CITY OF CODY
PLANNING, ZONING AND ADJUSTMENT BOARD AGENDA
MEETING OF TUESDAY, JANUARY 9, 2024 AT 12:00 P.M. (NOON)
CODY CITY HALL COUNCIL CHAMBERS, 1338 RUMSEY AVENUE, CODY, WY

| CITY OF CODY PLANNING, ZONING AND ADJUSTMENT BOARD STAFF REPORT | | | |
|---|--|------------------------------|---|
| SUBJECT: | FINAL PLAT FOR THE SOMMER MINOR SUBDIVISION—A 2-LOT SUBDIVISION. SUB 2023-03 | RECOMMENDATION TO COUNCIL: | X |

| SUBJECT: | FINAL PLAT AND CONSTRUCTION PLANS FOR THE MEADOWLARK MEADOWS SUBDIVISION—A 28-LOT SUBDIVISION. SUB 2022-07 | RECOMMENDATION TO COUNCIL: | X |

PLAT SHOWING - SOMMER MINOR SUBDIVISION

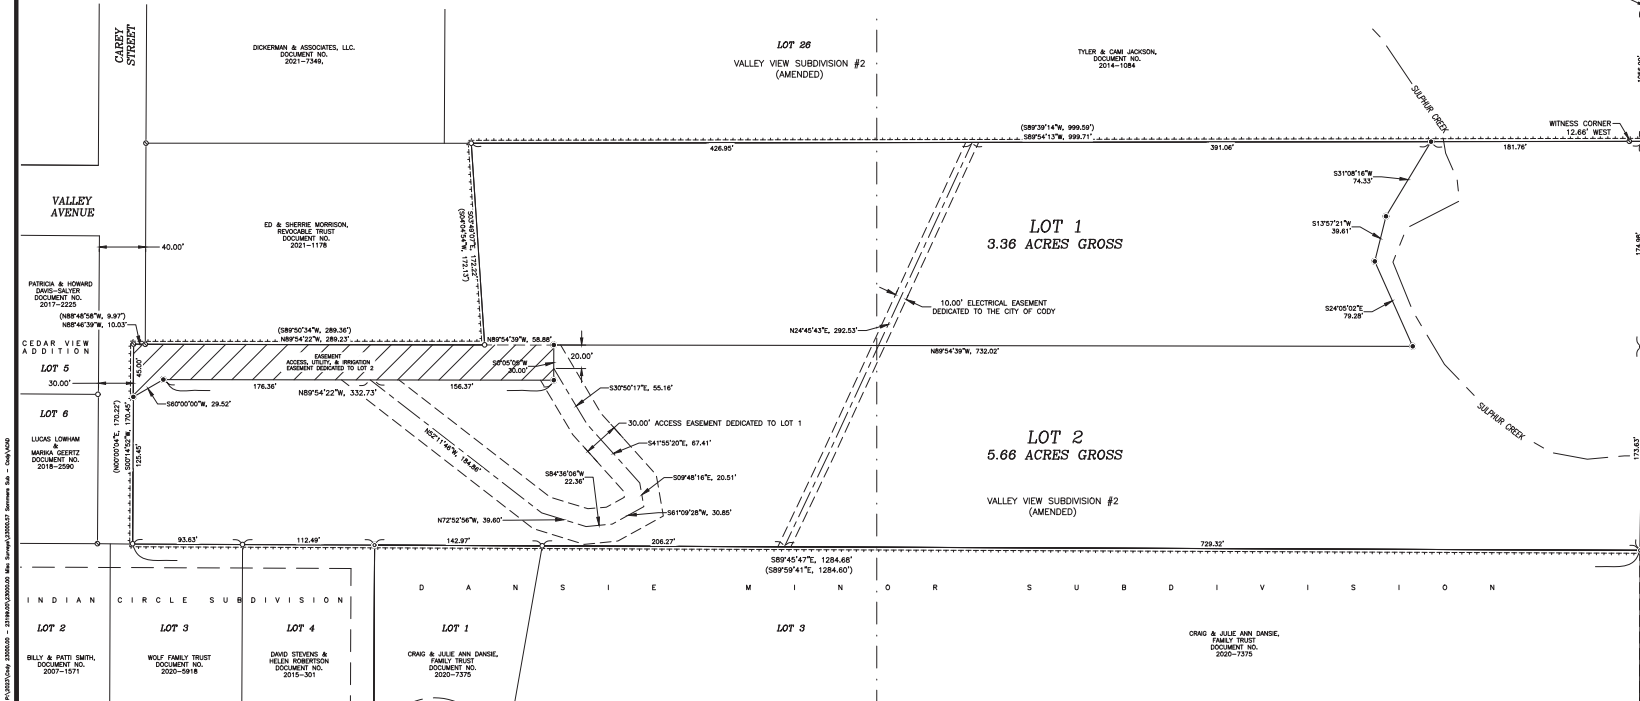
The final plat needs the following edits:

- a) With the change of ownership to a trust, verify the signatories.
- b) In the legend, remove the word "parcel" from "Easement parcel created his plat".

2. Prior to the mayor signing the final plat complete the edits to the final plat, including any change after verifying the signatories, and removing the word "parcel" from "Easement parcel created his plat" in the legend.

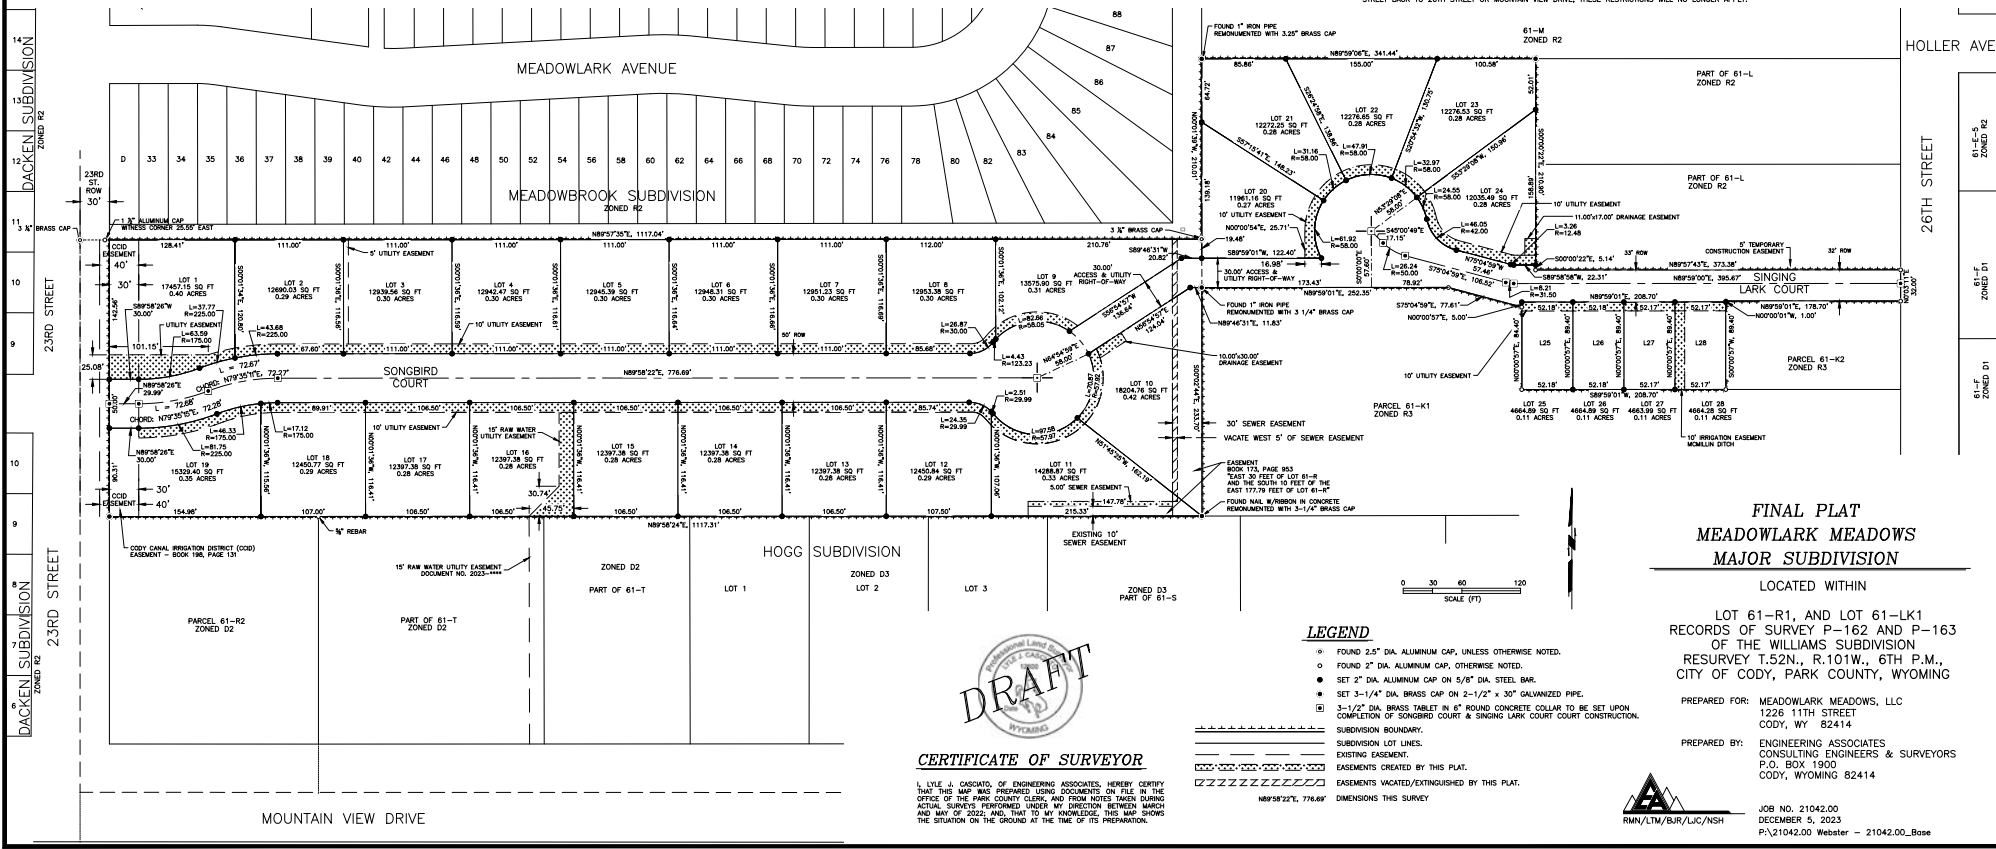
9. Incorporate the nine requested edits to the plat map noted in the staff report.

Status: Met, with the exception of adding the recording information for the off-site irrigation easement. That easement is yet to be recorded. It will be recorded prior to final plat, and referenced on the final plat.

4. Record the off-site irrigation easement and note the recording information on the final plat.
5. Provide a copy of the construction plans with approval signatures of the 3rd party utility providers (BHE, TCT and Charter) and the electric division.
6. Pay to the City the reduced cash-in-lieu-of-public-use-area fee in the amount of \$8,744.00.
7. Pay to the City the estimated cost of the 23rd Street frontage improvements in the amount of \$17,710.00.
8. Pay applicable utility fees (electrical estimate, tap fees for domestic water and raw water).
